SUBJECT: Forwards Figure 6-2, "Human Engineering Discrepancy Evaluation Flow Chart," for insertion as Pages 6-7 of detailed control room design review/plan.

Donald C. Cook Nuclear Plant Unit Nos. 1 and 2  
Docket Nos. 50-315 and 50-316  
License Nos. DPR-58 and DPR-74  
DETAILED CONTROL ROOM DESIGN REVIEW

Figure 6-2. Human Engineering Discrepancy Evaluation Flow Chart

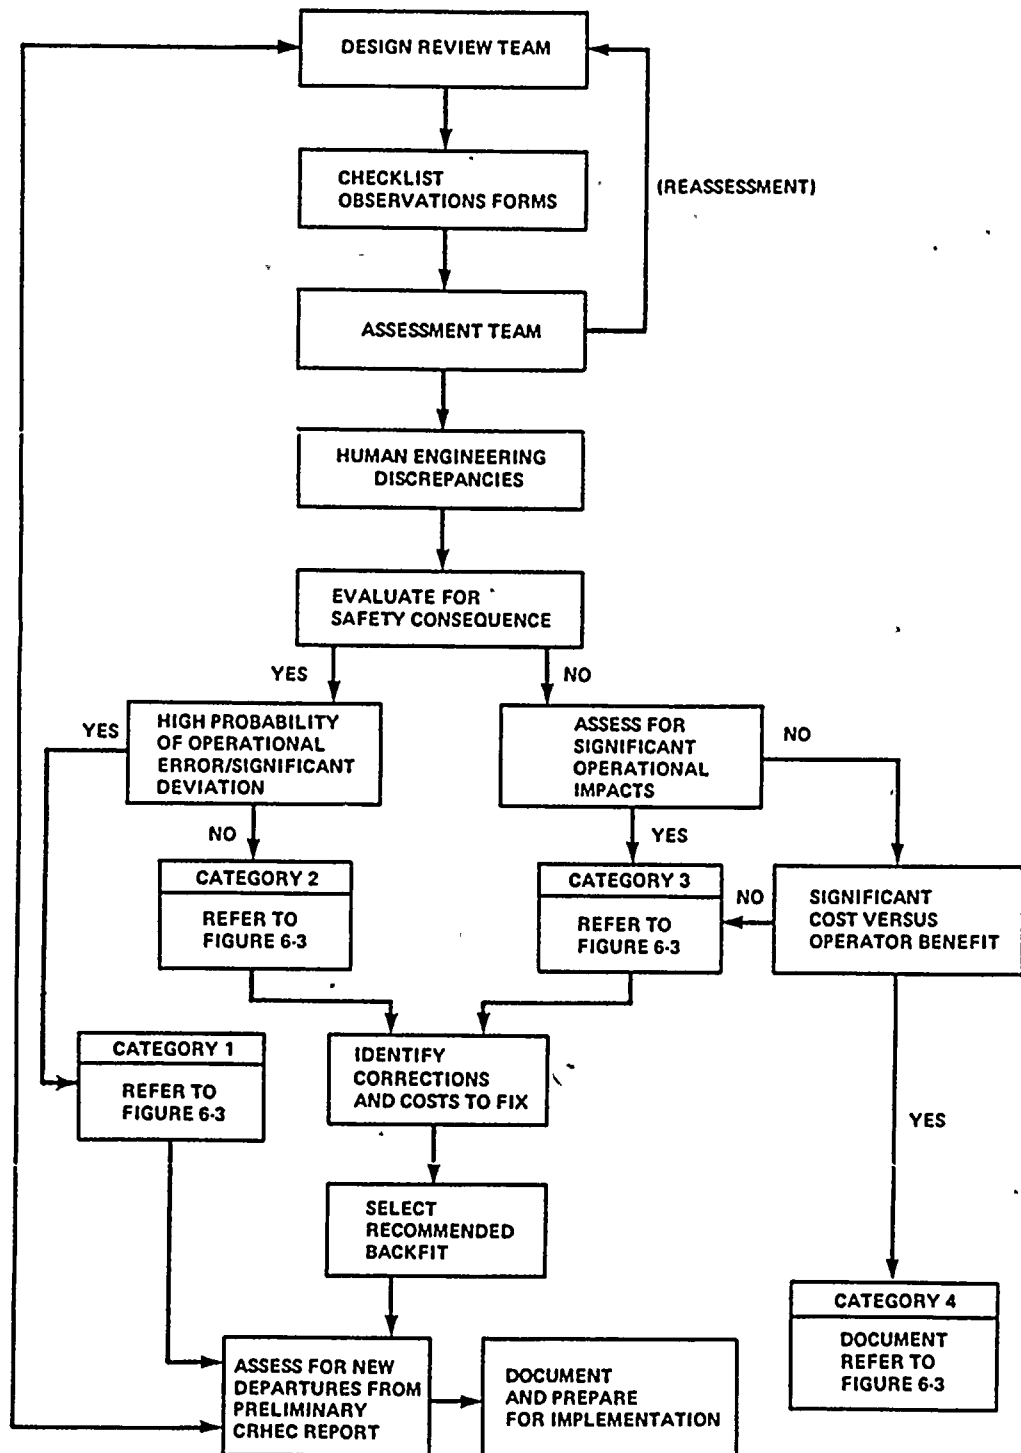
Figure 6-2 was inadvertently omitted from our Detailed Control Room Design Review (DCRDR) Plan sent to you on December 29, 1983 (AEP:NRC:0773C). The Figure 6-2 presents the methodology the Assessment Team will use to evaluate and categorize Human Engineering Discrepancies (HED). Although the figure may not change the NRC Staff Comments (Reference March 13, 1984 - Varga to Dolan Letter), we believe they should have the opportunity to review the figure prior to our tentatively scheduled meeting on May 8, 1984.

The attached Figure 6-2 is hereby provided for insertion as page 6-7 of our PROGRAM PLAN REPORT for a DETAILED CONTROL ROOM DESIGN REVIEW FOR INDIANA & MICHIGAN ELECTRIC CO. DONALD C. COOK UNITS 1 & 2.
